**Response to NRC Review Comments
Transmitted by Letter Dated June 22, 2001,
to the Nuclear Energy Institute Relating to**

***PWR Materials Reliability Program
Interim Alloy 600 Safety Assessment for US PWR Plants (MRP-44)
Part 2: Reactor Vessel Top Head Penetrations
EPRI TP-1001491, Part 2, May 2001***

MRP 2001-050NP

June 29, 2001

Figure 1
Locations of Leaking CRDM Nozzles at Ocone and ANO-1

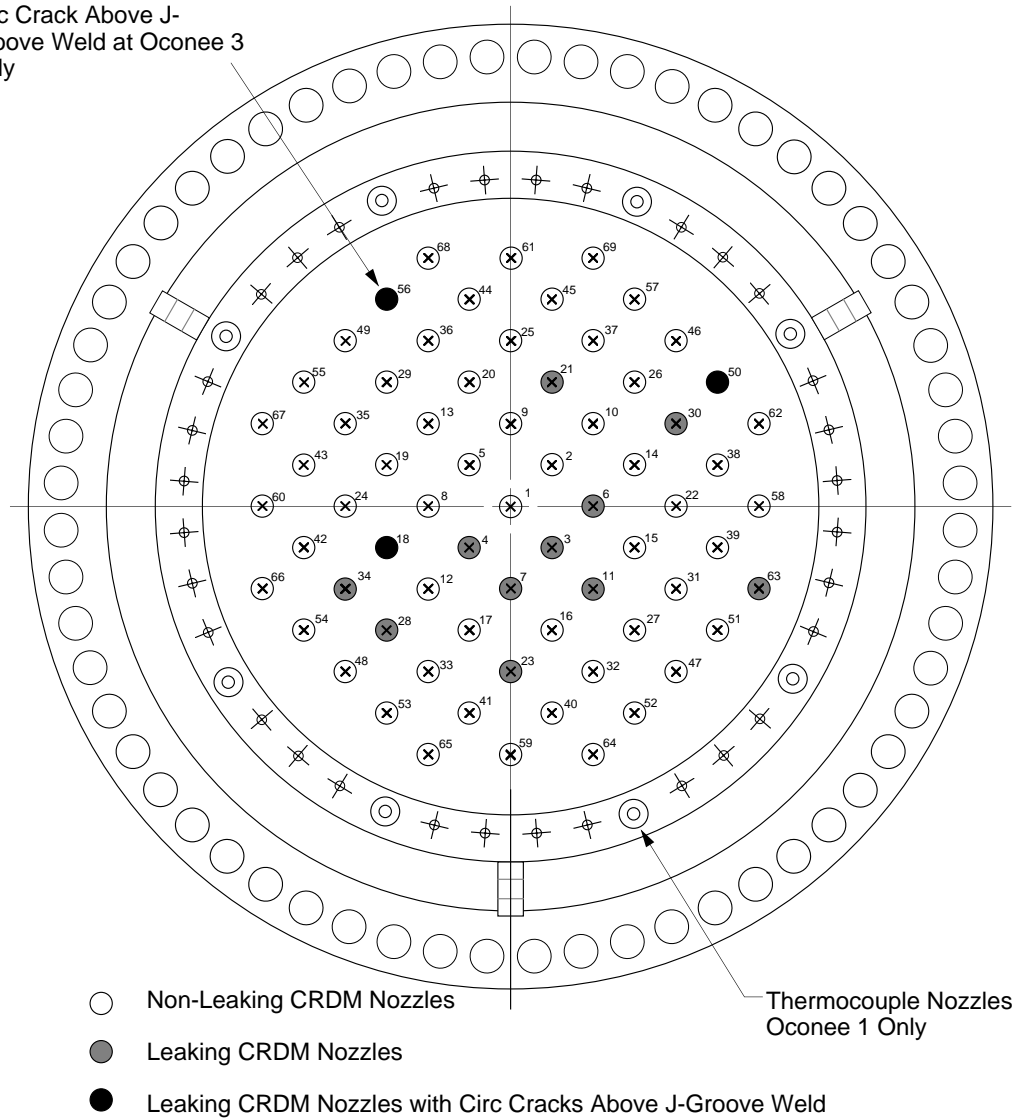
"Appropriate consideration of the interference fit incorporated into the initial fabrication of the vessel head penetrations (VHPs) is important in evaluating the ability of visual leakage detection methods (e.g., boric acid walkdowns) to accurately identify through-wall degradation at the subject locations. While the recent instances of cracking in several VHPs at ANO-1 and Oconee Units 2 and 3 indicate that it is possible to detect through-wall flaws caused by primary water stress corrosion (PWSCC) based on boric acid walkdowns that can look under the insulation, the information provided in Section 3 of the MRP-44, Part 2 report does not support the conclusion that these events were "bounding" (i.e., that, for a similar size through-wall flaw at some other facility, an equivalent or greater amount of leakage would be expected)."

- As shown in Figure 1, Oconee and ANO-1 experience demonstrates that leakage can be detected from nozzles adjacent to the central nozzle and in peripheral locations. This provides confidence that leakage can be detected regardless of location on the head.

Figure 3
Actual Interference Fits of Leaking CRDM Nozzles at Ocone 1, 2 and 3 and ANO-1

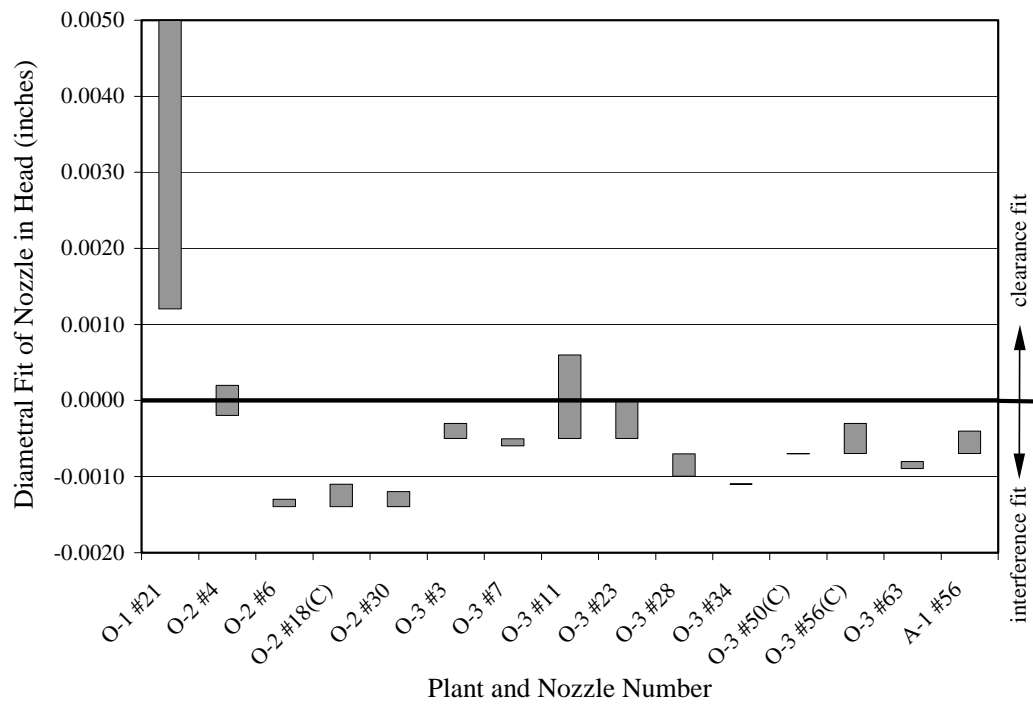
"In order to better understand the leakage potential of PWSCC at VHP locations, and to assist in understanding how comparisons can be made to the leakage potential for VHPs at other facilities, the staff request additional information detailing the precise interference fits (as opposed to a range of values) for the VHPs which leaked at ANO-1 and Oconee."

Figure 3 shows the range of fits for the leaking CRDM nozzles at Oconee and ANO-1. The information provided during the June 7 meeting for Oconee 1, Oconee 3 and ANO-1 has been supplemented with data for the four leaking nozzles at Oconee 2. The three nozzles found to have circumferential cracks above the J-groove weld are appended with "(C)" in the figure.

The data in Figure 3 show that one nozzle had a clearance fit rather than the specified small interference fit. The remaining nozzles had at least one end of the interference fit region within the specified tolerance. It should be noted that three of the four leaking nozzles at Oconee 2 had interference fits of 0.0014 inches at one end and at least 0.0011 inches at the other end. In summary, leaks have been confirmed from fourteen nozzles with confirmed initial interference fits, including three nozzles with at least 0.0014 inches of assembly interference.

Figure 4
Typical FEA Model of Central CRDM Nozzle

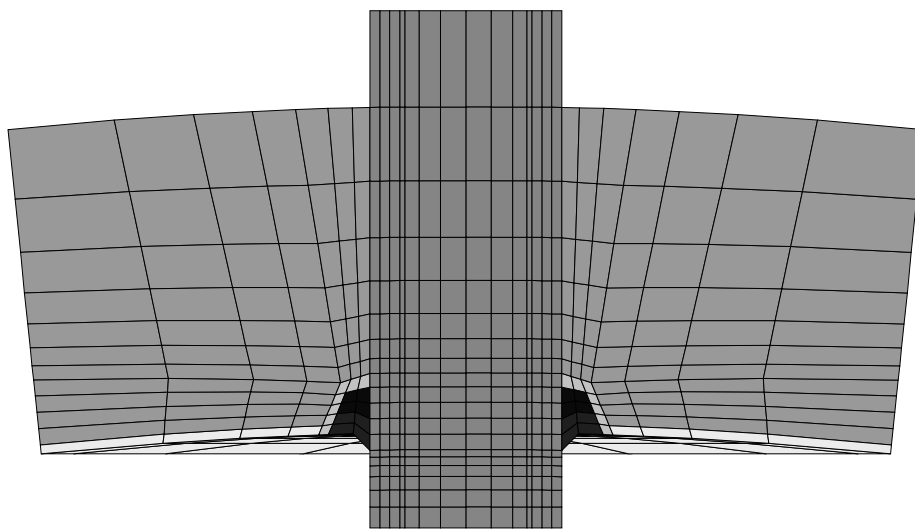
"The staff notes that, based on information in ASME Code Section II, Part D, the coefficient of thermal expansion for Alloy 600 is slightly greater than that for low alloy vessel steels throughout the temperature range of interest (70 °F to 600 °F). This would lead to the conclusion that the magnitude of the interference fit would grow as the vessel was heated up from room temperature to operating temperature. Further, internal pressurization of the VHP nozzle may be expected to further expand the nozzle into the vessel head penetration. Other potential effects related to RPV head distortion at pressure, flange rotation, and/or vessel head penetration ovalization are not discussed in Section 3.0. Address how these factors may affect central and peripheral VHPs differently. Provide additional information to support your statement that "...analyses show that the initial fit tends to open up at operating temperature and pressure." Provide details on the finite element analysis (FEA) of the RPV head used to support this statement, including modeling assumptions, boundary conditions and results."

Second order effects such as deflection and ovalization of oblique nozzles under pressure loading are assessed by finite element modeling of the nozzle and vessel head. Each of the NSSS vendors and EPRI has models of reactor vessel top head nozzles. Figures 4 and 5 show typical models of central and peripheral row CRDM nozzles and the associated J-groove welds. The models shown include the nozzle, a sector of the vessel shell, J-groove weld, J-groove weld buttering, and vessel cladding. Boundary conditions are imposed on the sector of the vessel shell to simulate the nozzle being installed in a complete spherical shell, and to model the initial

Figure 7
Visual Inspection of Oconee 3 Reactor Vessel Head (Leaking Nozzle 56)

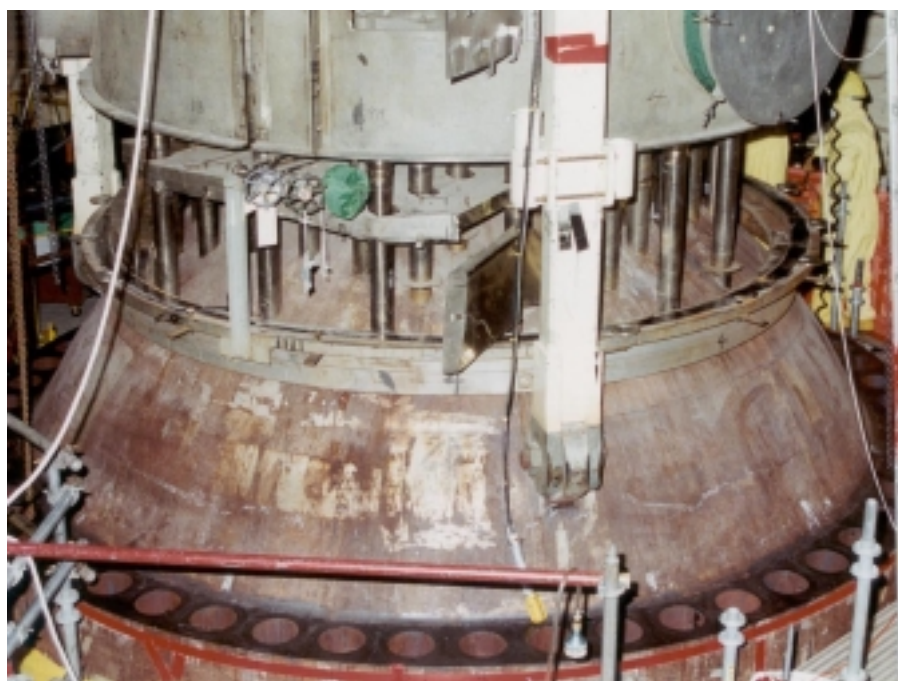
"At a public meeting on June 7, 2001, at NRC headquarters, the industry representatives described visual examinations conducted under the insulation at several PWRs. Provide any photographic documentation that can serve to demonstrate the expected conditions, accessibility and inspectability of the RPV head for such arrangements."

- Figure 7 is Oconee 3, where visual inspection was performed through access ports that had previously been cut in the shroud. Leakage is clearly visible in the photograph.

Figure 13
Weibull Plot of Fraction of Nozzles With Leaks vs. Effective Degradation Years

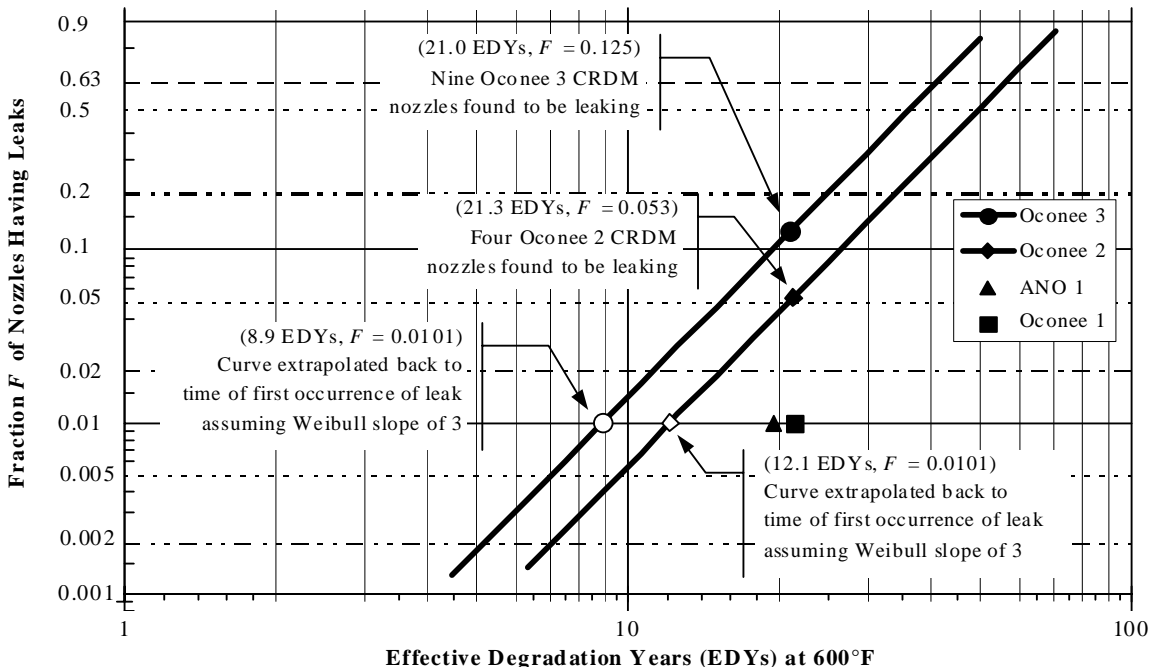
"In the subject report, the recommended inspection of nine plants for fall outage 2001 is based on consideration of the 25 plants in the first three assessment groups that have equivalent time at temperature to be within 10 EFY of the Oconee 3 condition. Explain the basis for selecting the 10 EFY cut off criteria for near-term inspection. Additionally, provide justification for not selecting for re-inspection plants with high rankings that were only partially inspected in the past."

The 10 year cutoff criterion was established by engineering judgment and by a Weibull analysis of the leakage experience at Oconee and ANO-1. A Weibull analysis was used since it provides a statistical model that shows the expected distribution of failures as a function of time. Industrial experience has shown that Weibull analyses provide good models for occurrence of PWSCC, both in nozzles and in steam generator tubes, as well as in laboratory SCC tests.

Figure 13 shows the fraction of leaking nozzles at Oconee 1, Oconee 2, Oconee 3 and ANO-1 plotted versus the effective degradation years (EDYs) adjusted to 600°F. The time to a first leak at Oconee 2 and 3 was estimated using a Weibull slope of 3 which is typical for PWSCC of Alloy 600 materials in the temperature range of interest. The data in this figure suggest that the initial leaks at Oconee 2 and 3 most likely occurred prior to initial detection in 2001.

Figure 14
Direction of Crack Propagation

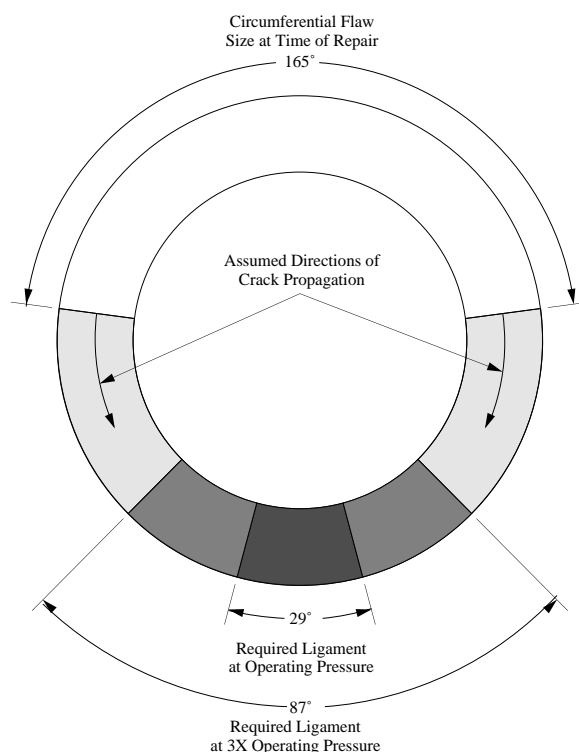
Section 5.0 Comment 1

The time for the Oconee 3 circumferential cracks above the J-groove weld to grow from the reported 165° arc length to the allowable 273° arc length noted in Section 5.0 of MRP-44 was computed as at least 4-5 years by two independent methods.

Both calculations were performed assuming that the cracks propagate in a circumferential direction around the nozzle from both crack fronts as shown in Figure 14. This is consistent with inspection results from Oconee 3 which showed that the cracks had essentially the same arc length on the inside and outside surfaces and is also consistent with the expected direction of primary crack growth for a through-wall crack in a cylindrical shell under internal pressure loading. Note that the finite element stress analysis results reported under Section 5.0 Comment 3, show that when the crack has reached 180° arc length, the welding residual stresses have been significantly reduced such that the primary direction of crack growth is expected to be around the nozzle as shown.

Figure 15
Stress Analyses of Peripheral CRDM nozzle in Intact (a) and Cracked (b) Configurations

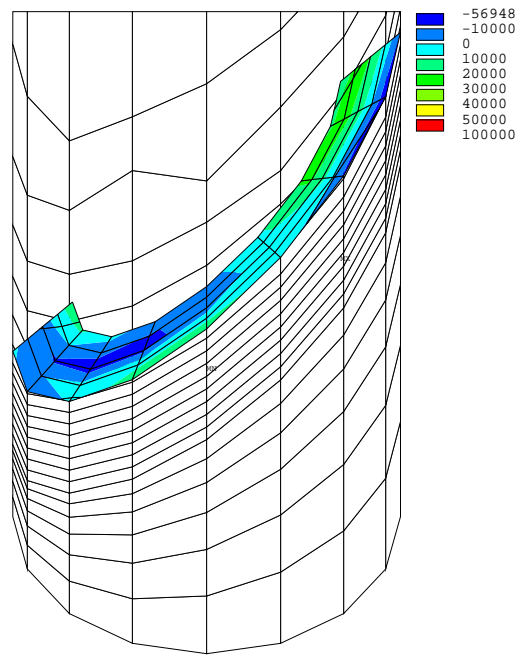
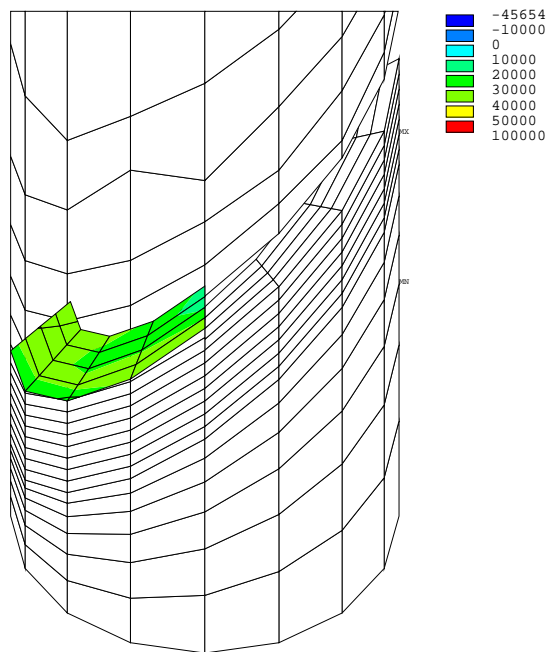
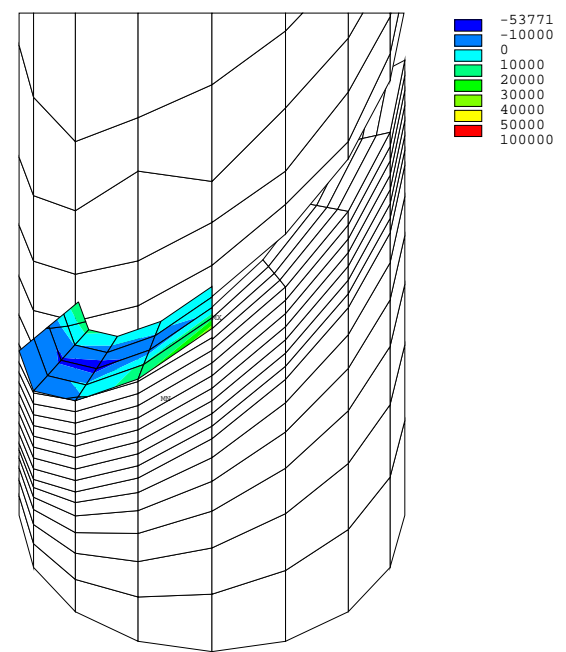
"At a public meeting on June 7, 2001, at NRC headquarters, the industry representatives described finite element analyses (FEA) for circumferential cracks in peripheral CRDM nozzles. Provide details of the FEA modeling assumptions (such as symmetry, boundary conditions and residual stresses), the resultant stresses, and the applied stress intensity factors. How do these parameters change (e.g., stress redistribution) with crack growth in the nozzles?"

Finite element models of CRDM nozzles have been developed by each of the NSSS vendors and EPRI. Typical models are described under the response to Section 3.0 Comment 3 and in previous submittals to the NRC in 1993-94. Typical models for central and peripheral row nozzles shown in Figures 4 and 5 have 180° symmetry and boundary conditions imposed on the sectors of the head shell to simulate an infinite shell. The J-groove welds in these models were simulated by combined thermal and structural analyses. A transient thermal analysis was used to generate nodal temperature distributions throughout the welding process. These nodal temperatures were then used as inputs to structural analyses which calculated resultant thermally-induced residual stresses as the welds cooled and gained strength. The sequence of thermal analysis followed by structural analysis was duplicated for each simulated weld pass.

Analysis results were presented at the June 7 meeting showing stresses parallel to and perpendicular to the J-groove weld for a peripheral nozzle in the intact operating condition, including the effects of welding residual stresses and hydrostatic testing prior to operation, and with the weld cracked 180° around on the uphill side of the nozzle at the elevation of the weld root. These results are repeated in Figure 15, which also shows the values for the stress contours. These data show that stresses are significantly reduced after cracking has removed some of the constraint that caused high welding residual stresses.

The model shown in Figures 4, 5 and 15 was not used to calculate crack tip stress intensity factors directly. Stress intensity factor calculations are currently being sponsored by the MRP using the finite element analysis results as inputs. Until such time as the finite element based stress intensity calculations are completed, calculations of crack growth have been performed using more traditional models such as described under Section 5.0 Comment 1.
